ATTACHMENT 5

Letter from M. E. Warner (NMC)

License Amendment Request 187

Revised Pages for Updated Safety Analysis Report
(USAR)

Figure 14.1.2-3

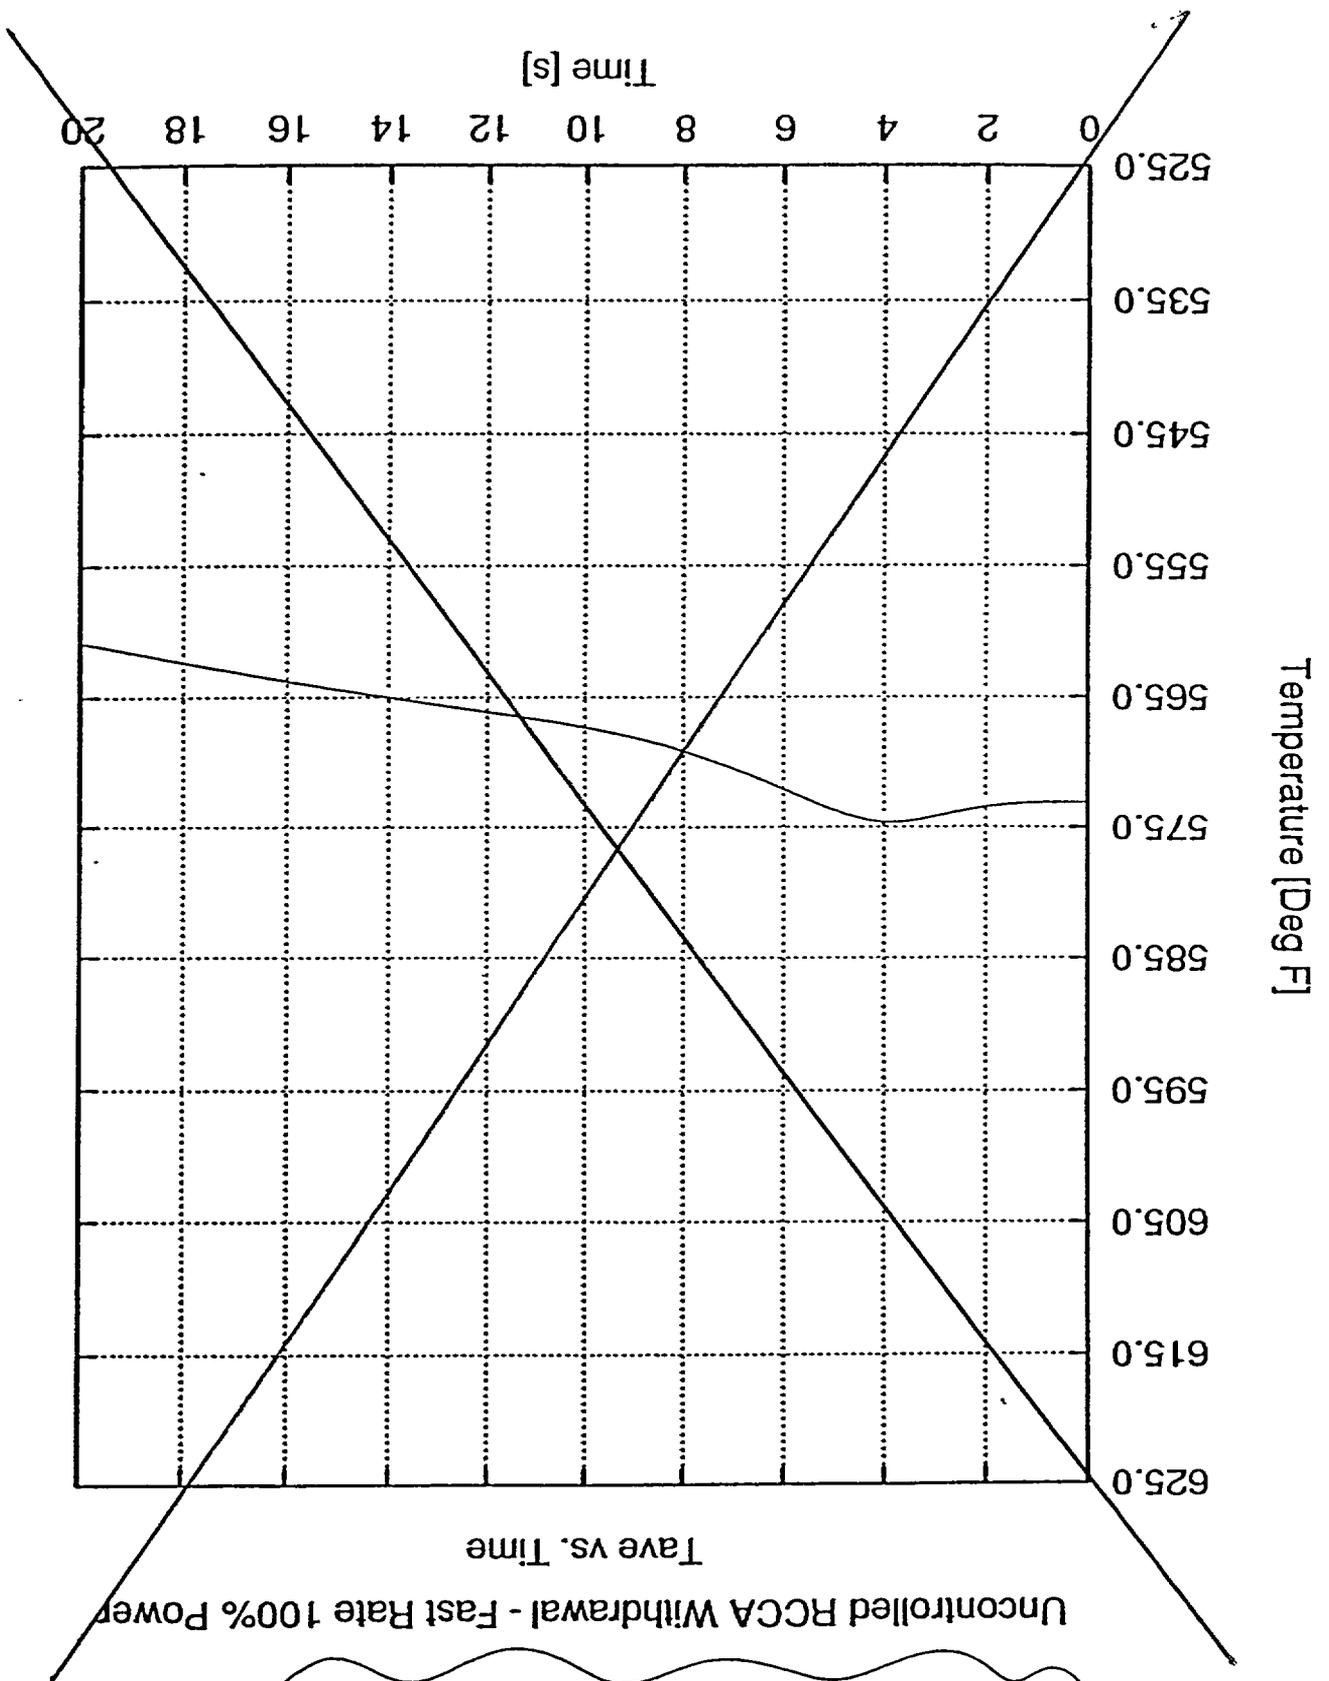
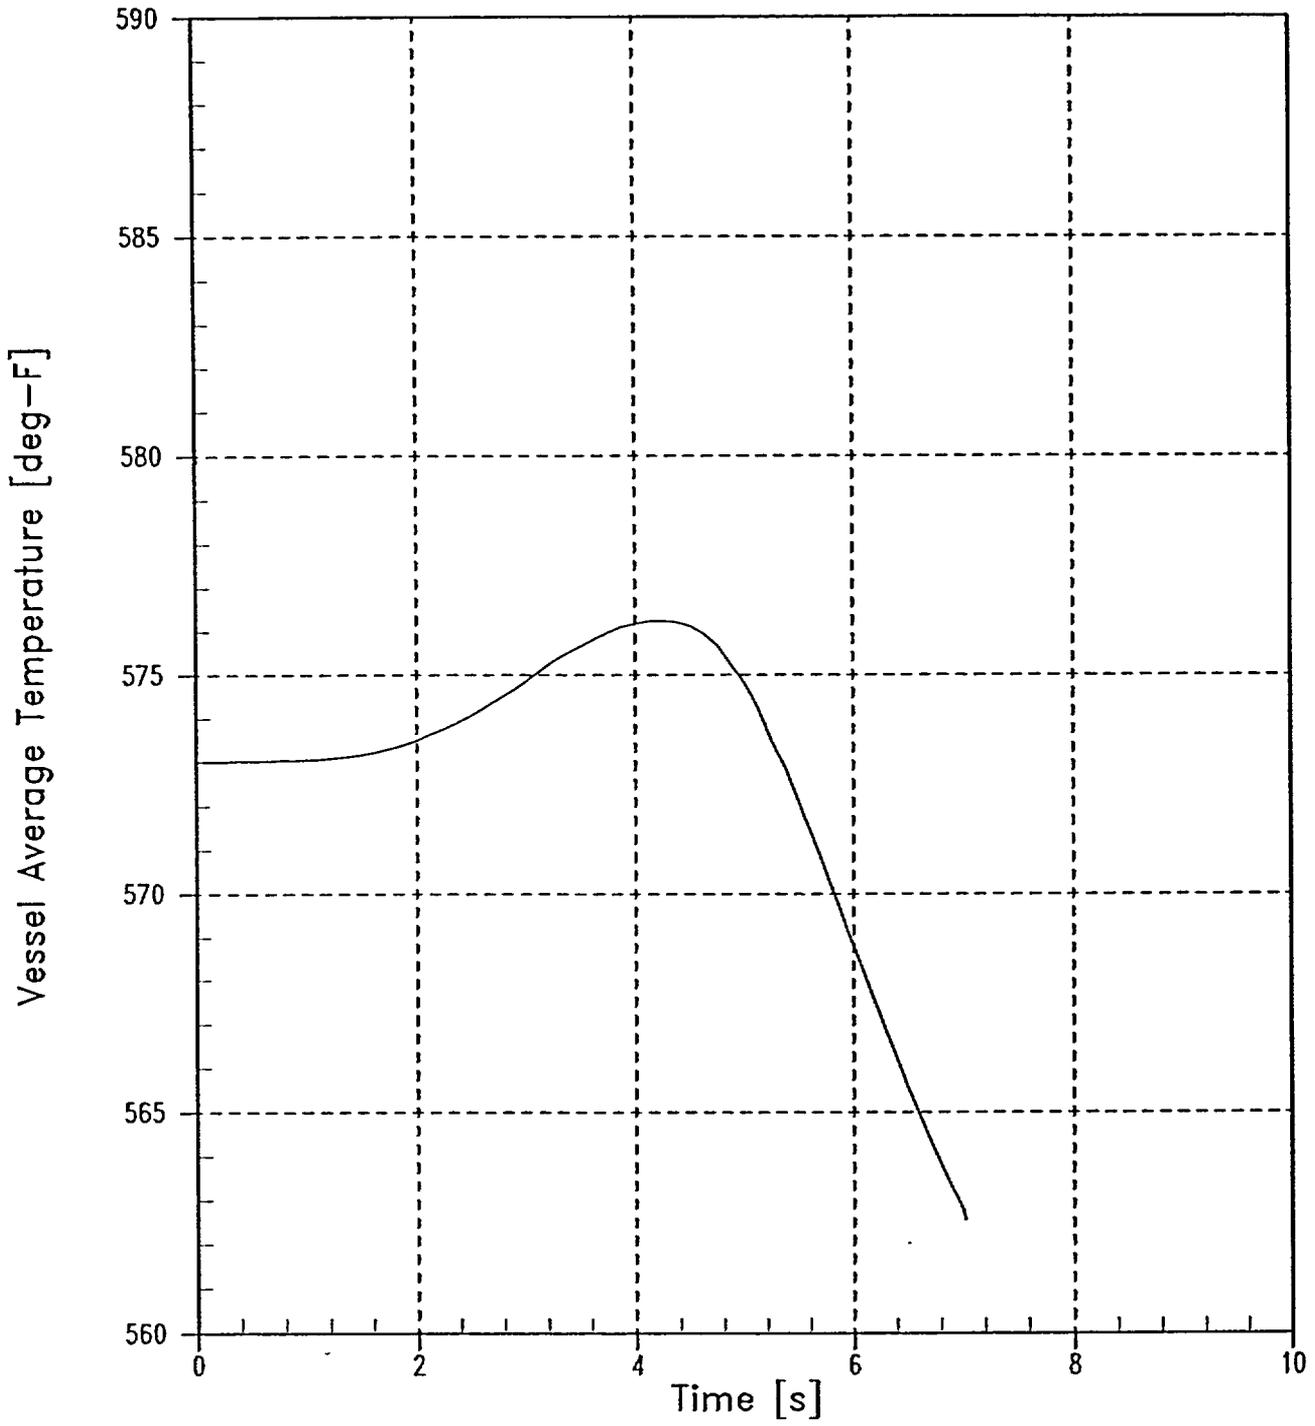
REPLACE WITH THE FIGURE THAT FOLLOWS

Figure 14.1.2-4

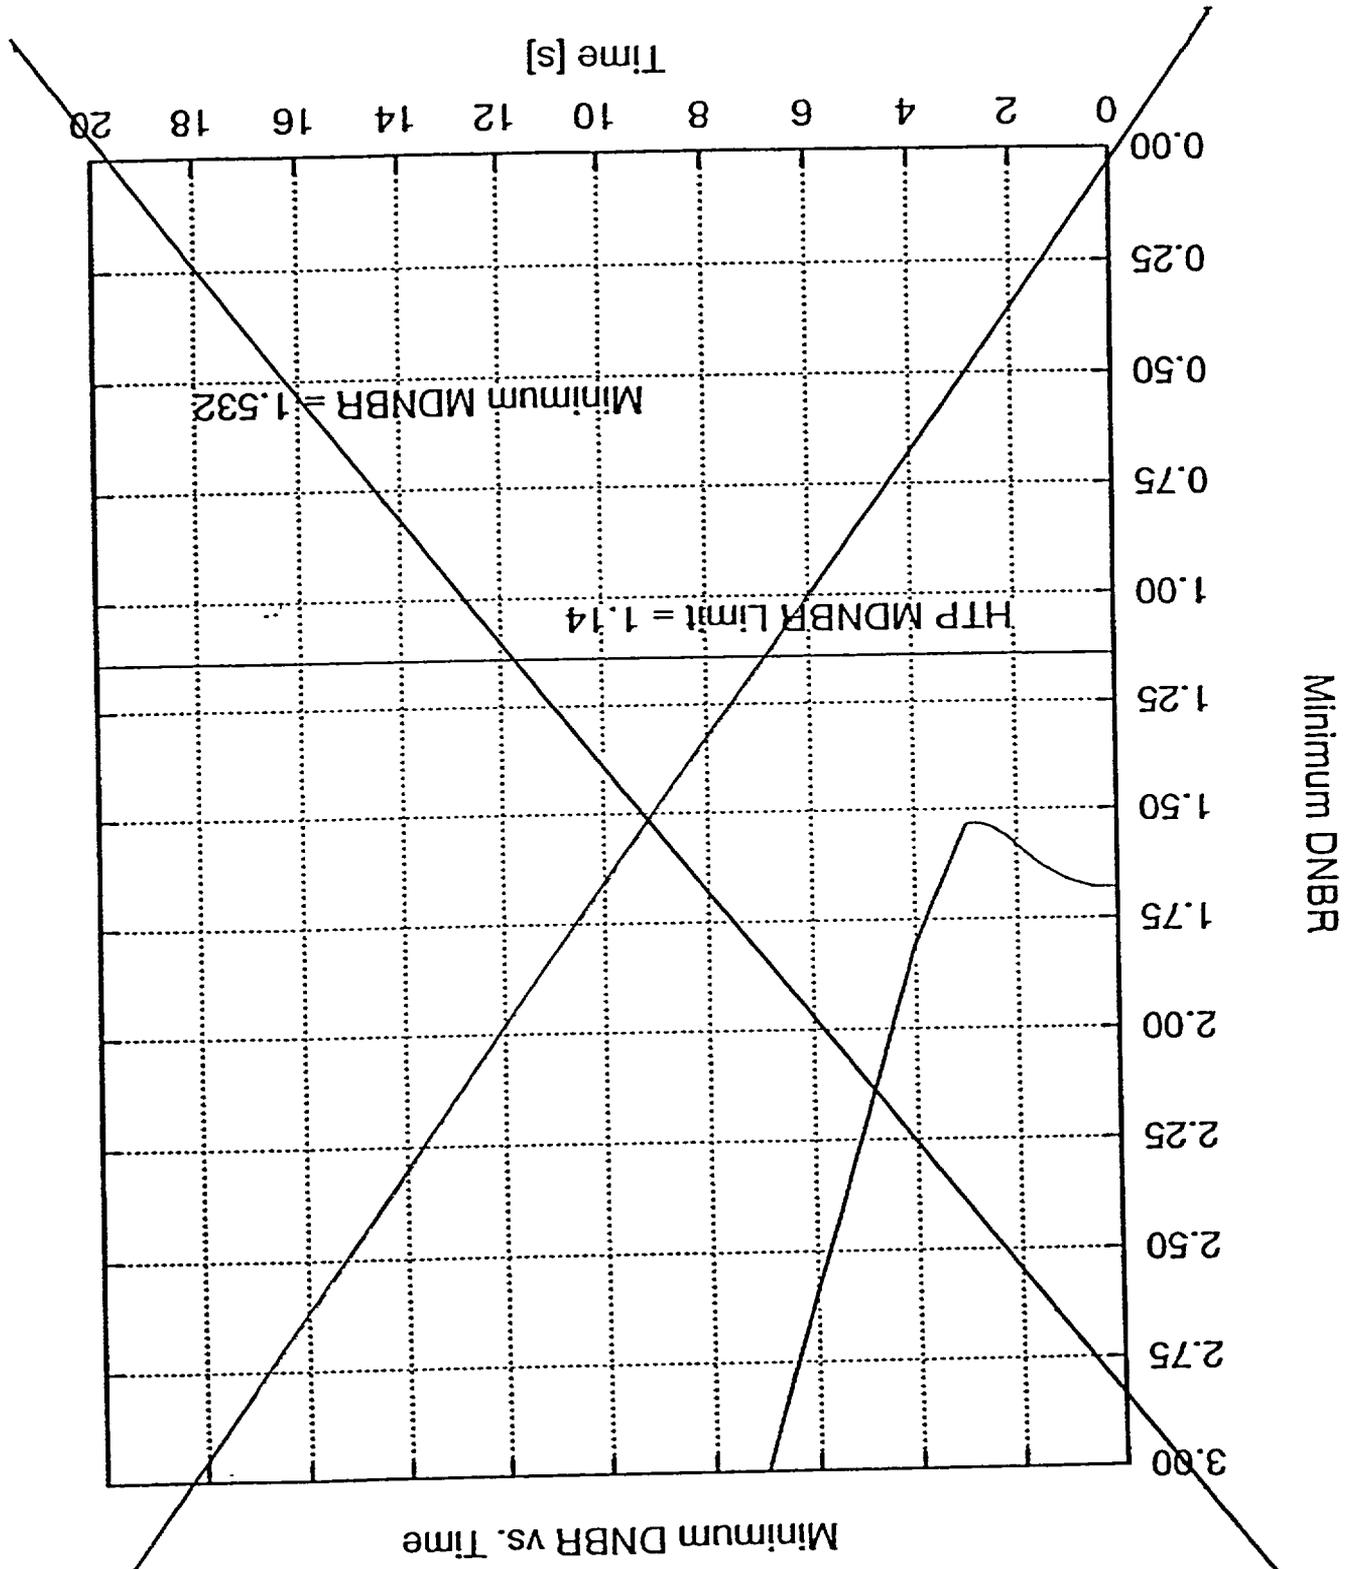
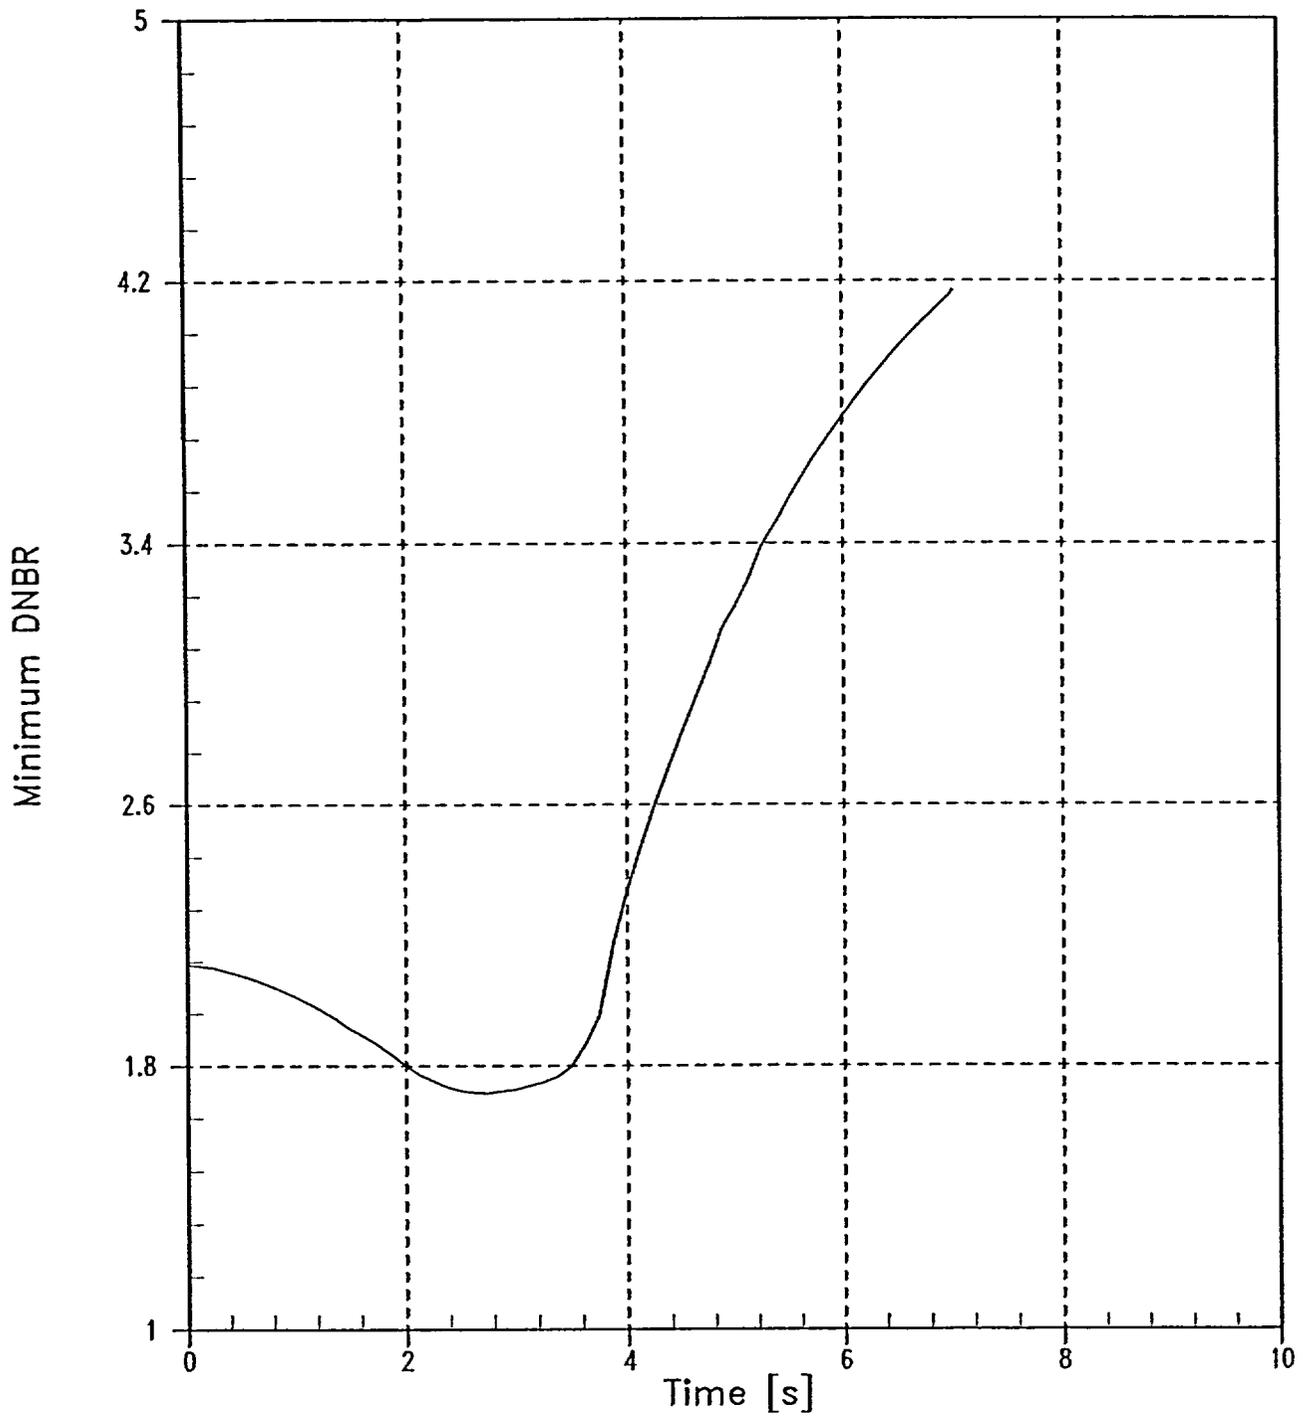
REPLACE WITH THE FIGURE THAT FOLLOWS
